Millennium Forms

BRRTS No. 02-65-587693

3-26-2024 DNR PowerPoint slides

"Site Investigation Report Not Approved and Next Steps"

Well Name
TRG MW-5

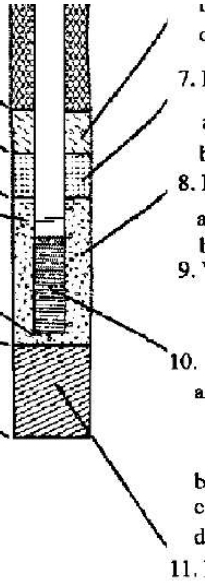
Other documents change -for example, the well forms...

Site Map (e.g. Utilities)

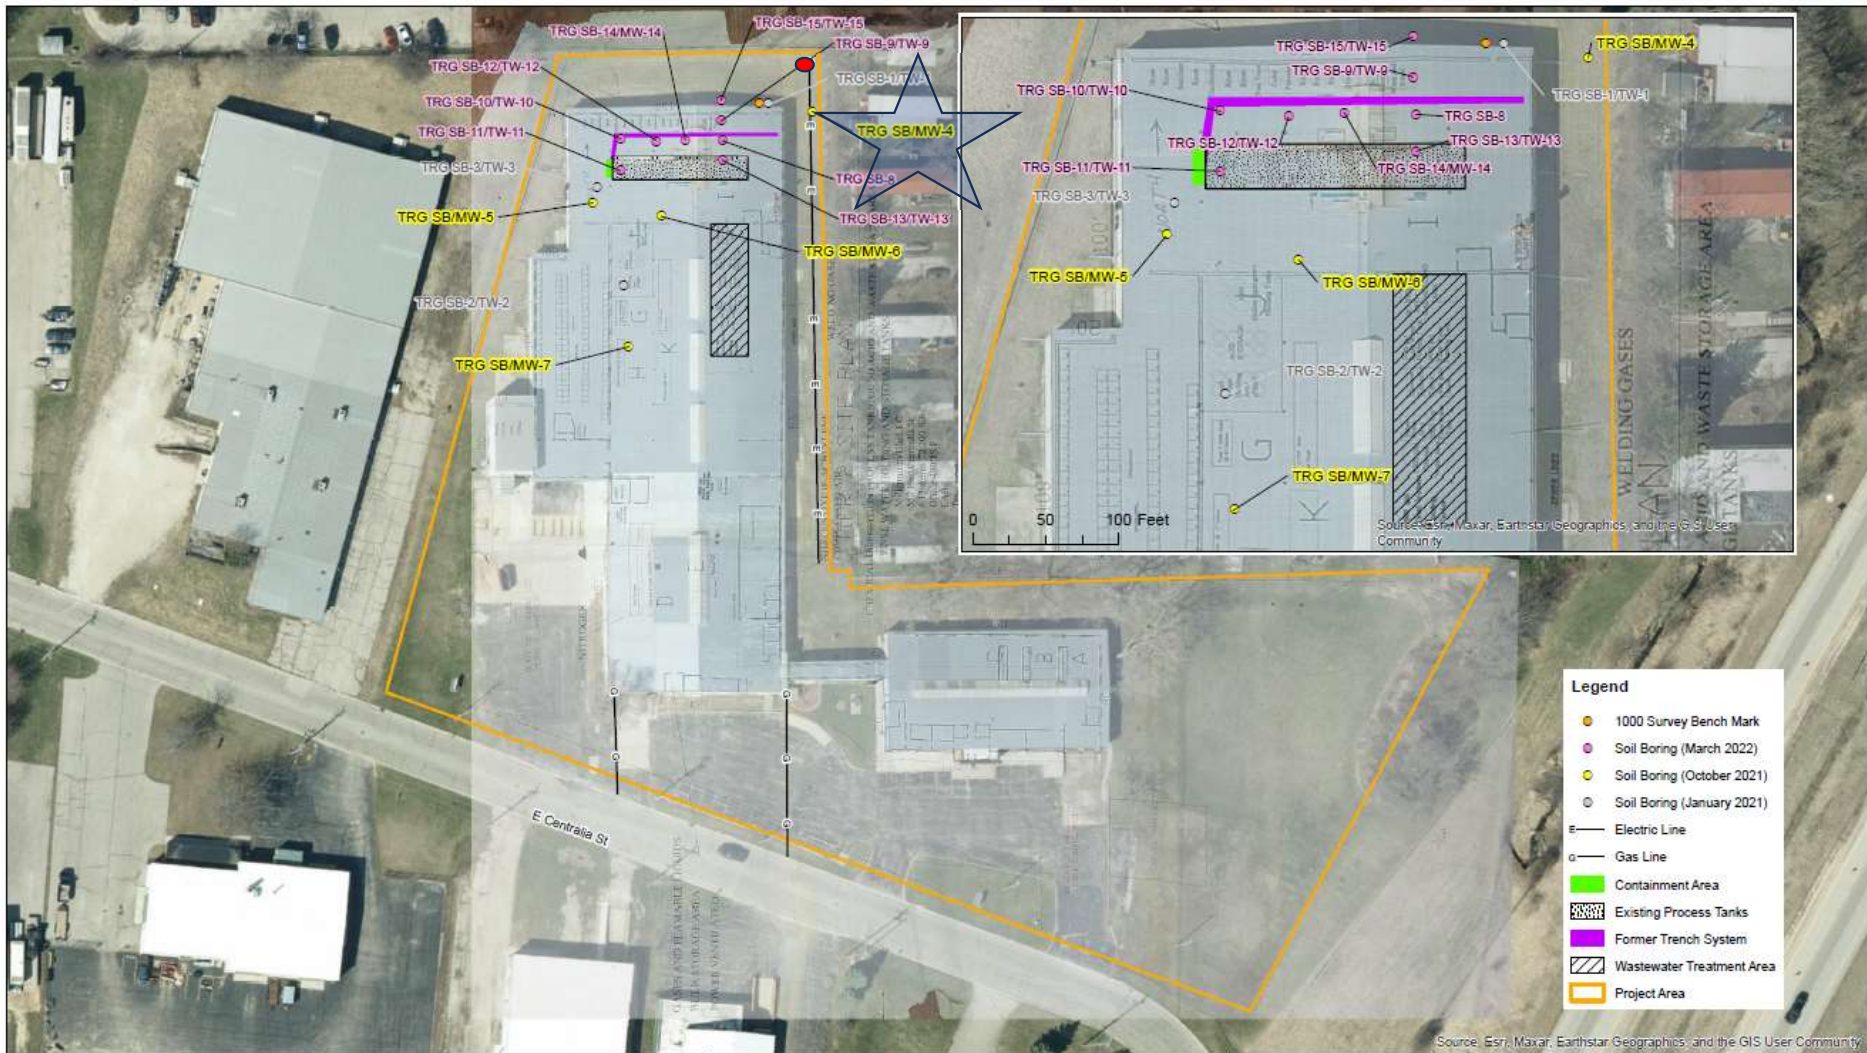
TRG states that preferential groundwater pathways, such as utility corridors, are not a concern. Provide the basis for TRG suggesting the utility backfill has the same hydraulic conductivity as the native glacial deposits. Discuss what the backfill material consists of and show the utilities on the map.

Underground Utilities There are underground utilities and sewer laterals to the south of the Property along East Centralia Street and along the southern property boundary of the Site. Stormwater on Site is conveyed via a system of swales toward the southern portion of the property. However, there is an electrical utility line located along the eastern boundary of the Property in the vicinity of the area of investigation (**Figure 2**). Because electrical lines are typically installed using directional boring methodology, it does not appear as though there are any preferential migration pathways due to underground utilities on the Property.

The well survey is not to MSL...

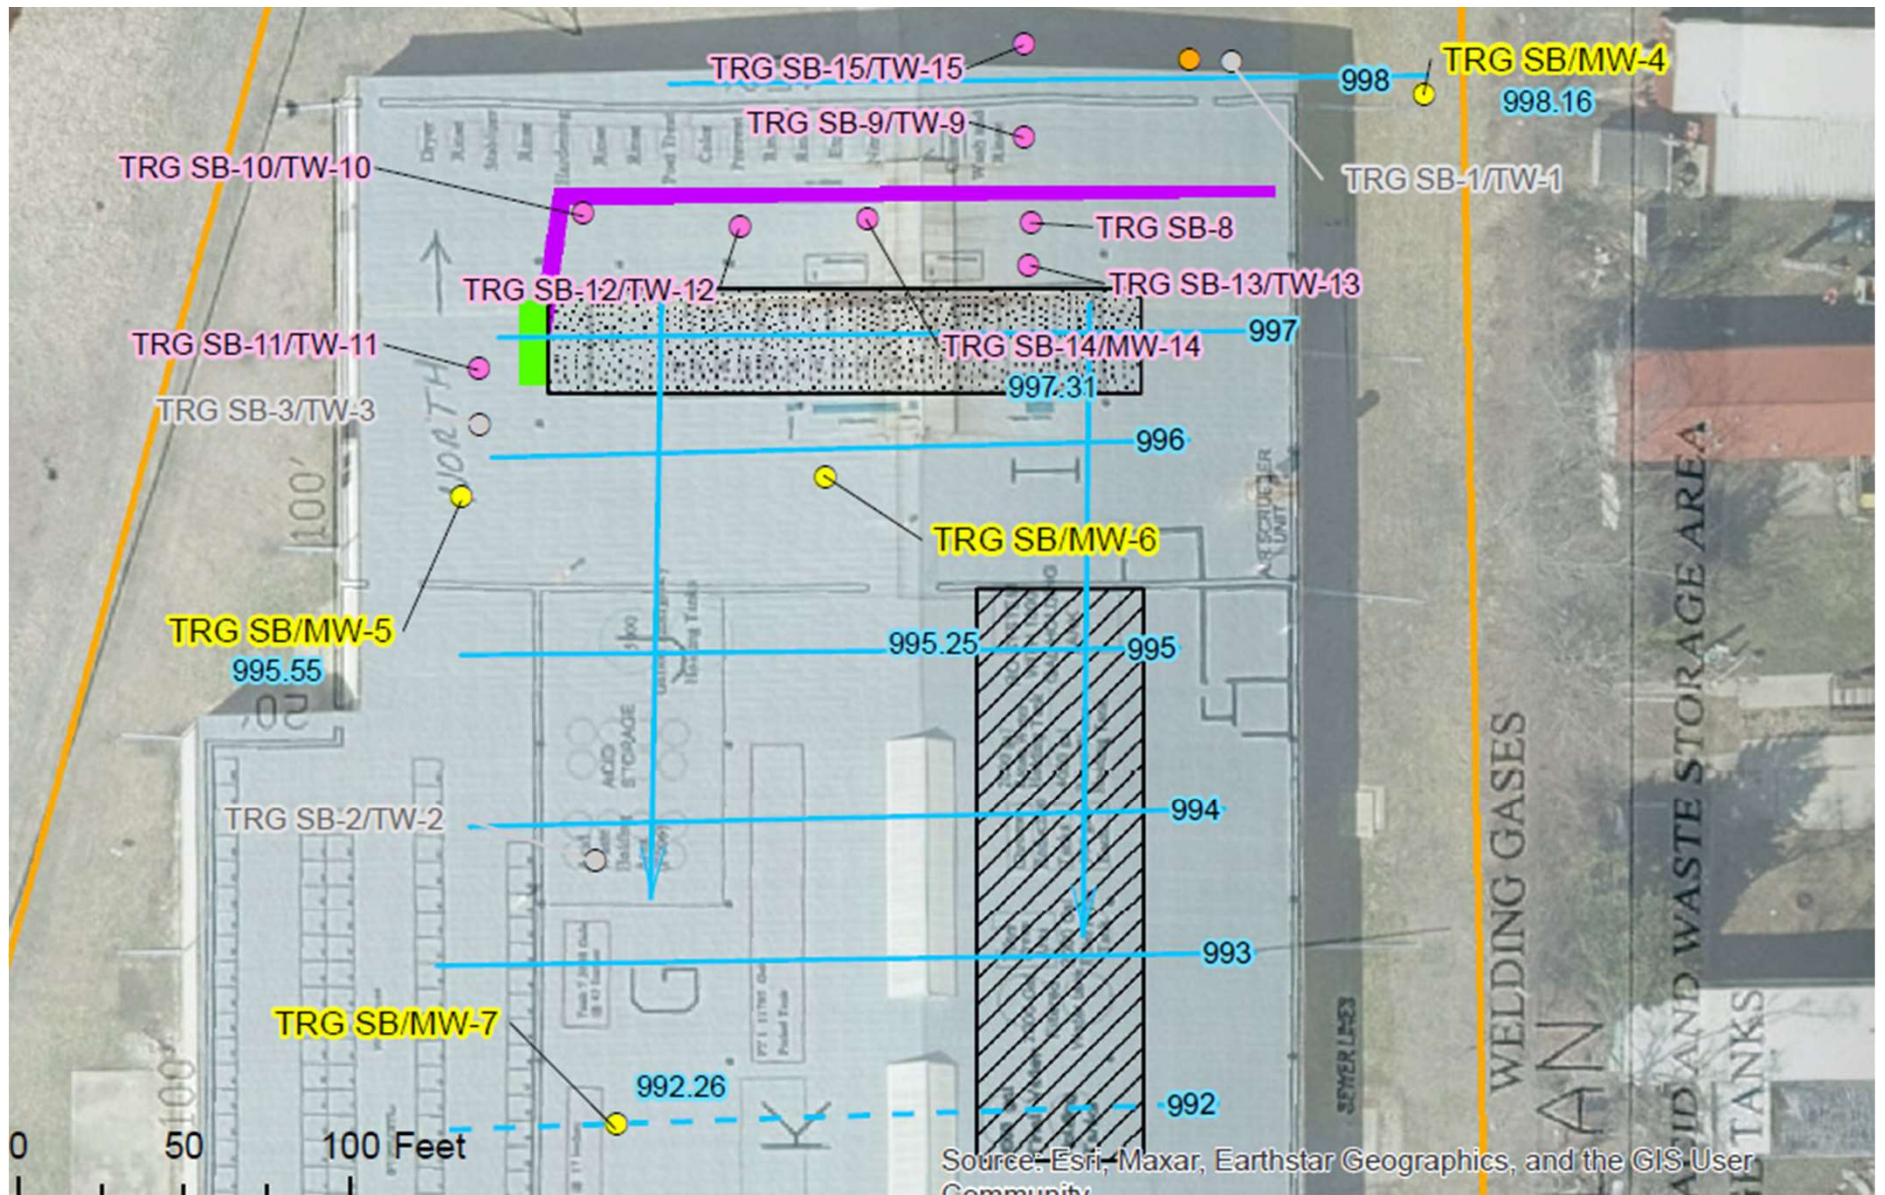
Page 11 states, “The elevation and horizontal location of each groundwater monitoring well were surveyed with respect to a known or designated benchmark on the Property. Elevations of the ground surface and top of the PVC well casing were surveyed.” Survey data must be relative to mean sea level to meet code requirements. No survey data were provided in the report.

5. Confirm the surveying methods will obtain the required accuracy (1-foot horizontal, 0.01 foot vertical). [141.065(2)]

***TRG RESPONSE:** As was stated in the WDNR approved workplan the elevations of the ground surface and top of PVC well casing were surveyed to a known or designated benchmark on the Property.*

Upon completion of the soil borings, monitoring wells, and HPV monitoring points, each location will be surveyed to establish the relative vertical elevation of each based on a local benchmark using GPS (horizontal) and laser level (vertical). These surveying methods will obtain the required accuracy of 1-foot (horizontal) and 0.01 foot (vertical).

Cross section issues

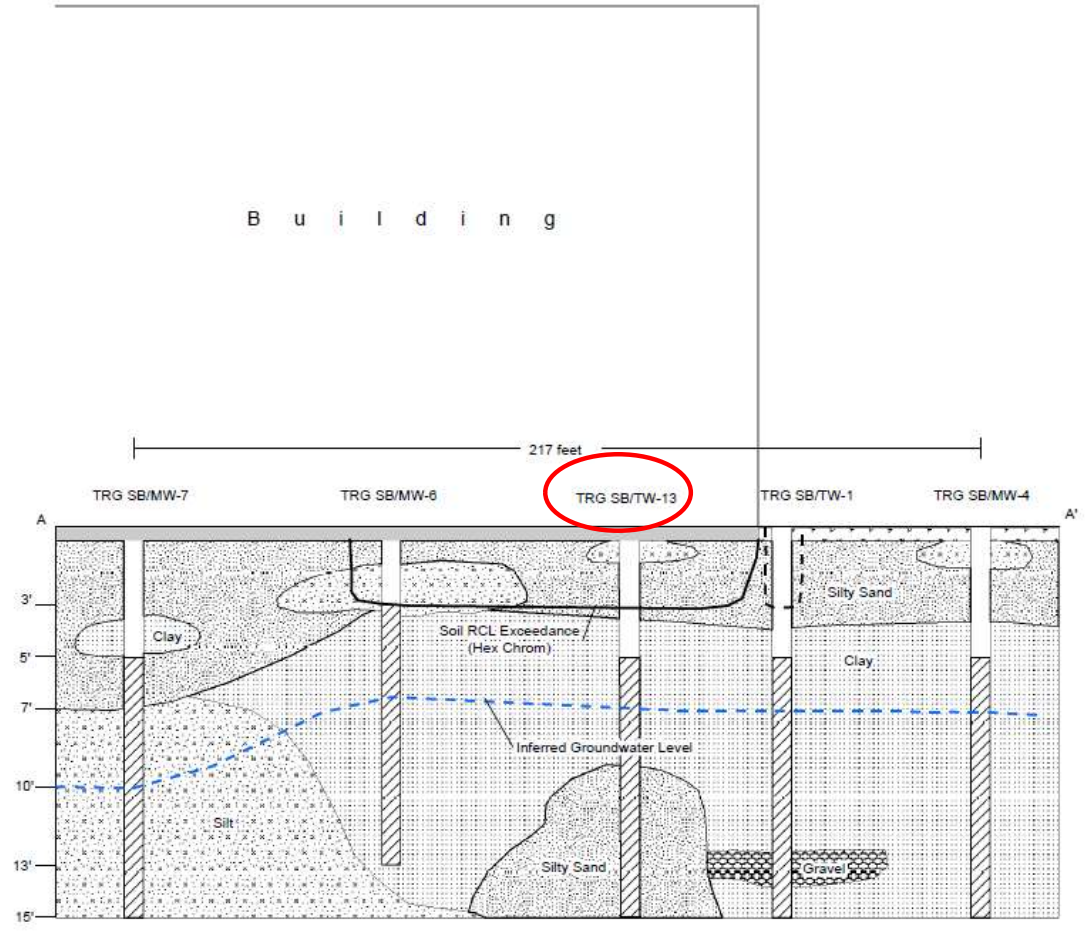
Figure 6 and 7, the geologic cross sections, contain errors and do not meet code requirements in Wis. Admin Code § NR 716.15 (2)(d).

- Soil descriptions must match the boring logs. For example, at TRG SB-5, the soil descriptions on the two cross sections are not the same and neither depiction agrees with the data on the soil boring log. Similarly, TRG MW-4 boring log does not match cross section.

***TRG RESPONSE:** Figures 6 and 7 have been updated to reflect the concerns noted above.*
